**Application for Permission Under Section 16 of the Town Planning Ordinance (Cap. 131) for Proposed Temporary Educational Institution (Teaching Farm) and Associated Excavation of Land for a Period of Three Years at Various Lots in D.D. 16, Wo Tong Pui, Tai Po, New Territories
(Planning Application No. A/NE-LT/794)**

Submission of Further Information

Responses-to-Comments table

Planning Application No. A/NE-LT/794

Scale: NTS	
Drawn by:	Date: 07/2026 Checked: Approved:
Job No. 312796	Figure No. B.3

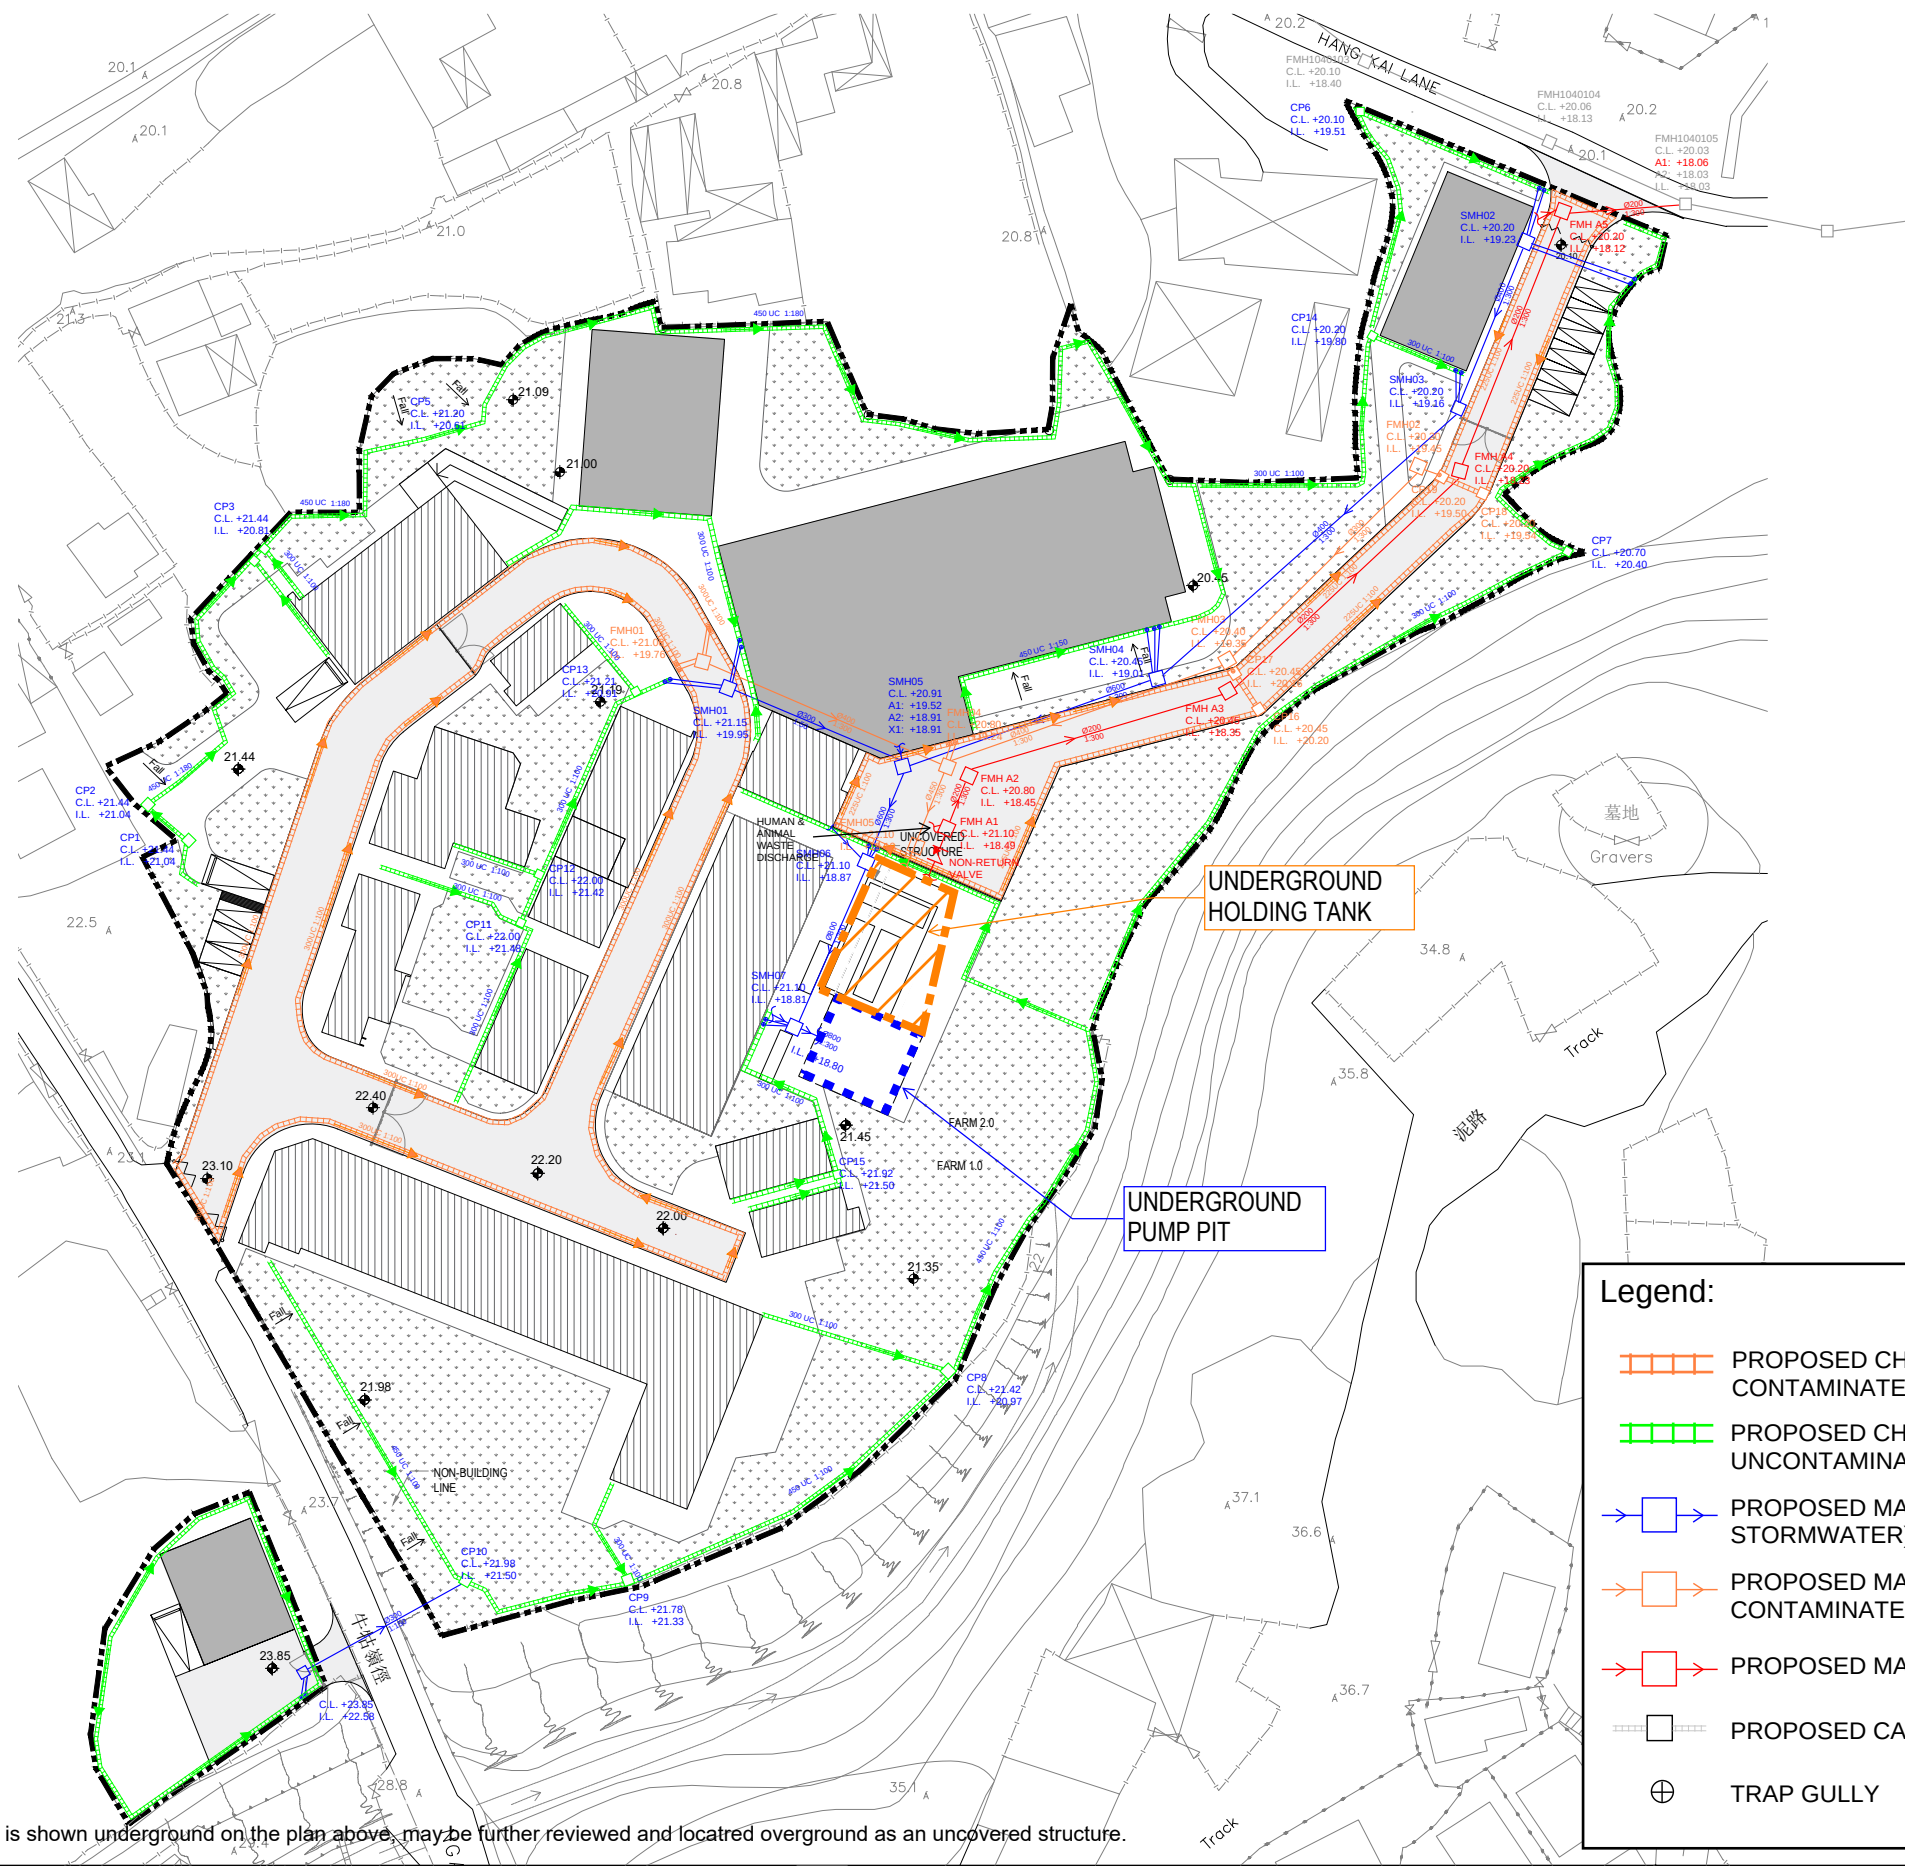
No.	Comments	Responses
	should be considered in the calculation. c) Figure No. B4 — Please demonstrate how the holding tank can collect the first flush only. With the current arrangement, after collecting the first flush, the incoming water will mix with the first flush and thus become contaminated water when overflow the weir to the pump pit. d) Catchpits should be provided at <u>all</u> turning point of U channel. e) Please clarify whether the outfall is submerged at Lam Tsuen River. If not, a pressure release chamber should be provided before discharging to Lam Tsuen River. f) RtoC (e) — The surface runoff from the surrounding areas passing through the site area should be included in the calculation. In addition, if this application has been approved for temporary use for 3 years, there may be a potential of further application for renewal of this use in the future. Therefore, as per Table 28 of Corrigendum No. 1/2022 of the SDM, the rainfall increases due to climate change by the end of the 21st century (16.0%) should be considered in the design. Furthermore, Table 31 of the same Corrigendum specifies that a design allowance for a rainfall increase of 12.1% (by the end of the 21st century) should be incorporated into the design. Sewerage Impact Assessment Comments from Land Drainage Division (LDD), DSD	channel, no hillside stormwater will discharge into the application site. In view of the above, it is considered reasonable to exclude the existing catchment from the calculation. The holding tank design is updated. There will be no overflow between the holding tank and the pump pit. Please refer to Appendix B for the replacement pages of the updated DSIA. The details of the drainage design within the site boundary will be submitted for BD's approval. All the drainage systems within the site will be managed by CityU Farm and will not be handed over to DSD. Noted, pressure release chamber will be provided before connecting to the public outfall. Please refer to Appendix B for the replacement pages of the updated DSIA. Please refer to the RtoC (a) and (b), the surface runoff from the surrounding area has been intercepted by existing government channel and it will not pass through the site. In view of the above, it is considered reasonable to exclude the existing catchment from the calculation. Please note that the proposed development is intended for temporary teaching farm use over the coming three years only, while the long-term use of the site has yet to be confirmed. On this basis, and having regard to the relatively short planning horizon, it is considered reasonable that the climate change factor is not applied in this submission.

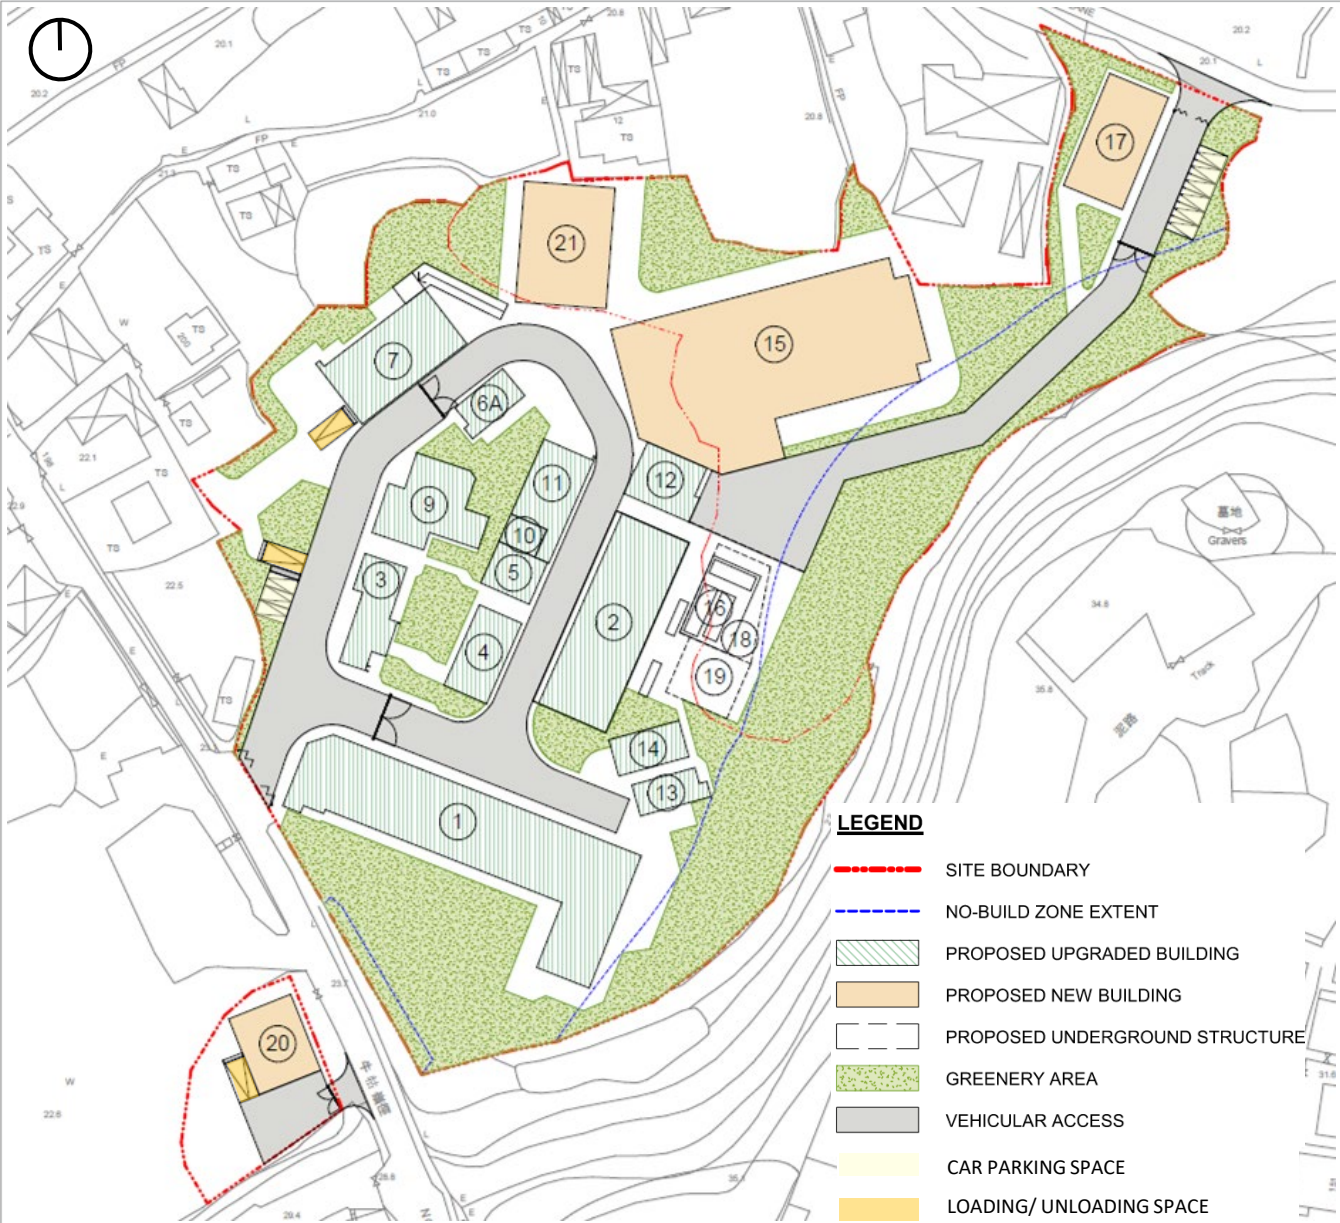
No.	Comments	Responses
	1. Table 4.3.2 and Figure No. 4.1: The name of Block 6A is indicated as “Machine Store” in the Table 4.3.2, but on Figure No. 4.1 as “Manure Store Block”. Please clarify.	Noted, Block 6A should be referred to as “Machine Store”. Figure No. 4.1 has been updated accordingly to ensure consistency with Table 4.3.2. Please refer to Appendix D for the replacement pages of the updated SPS.
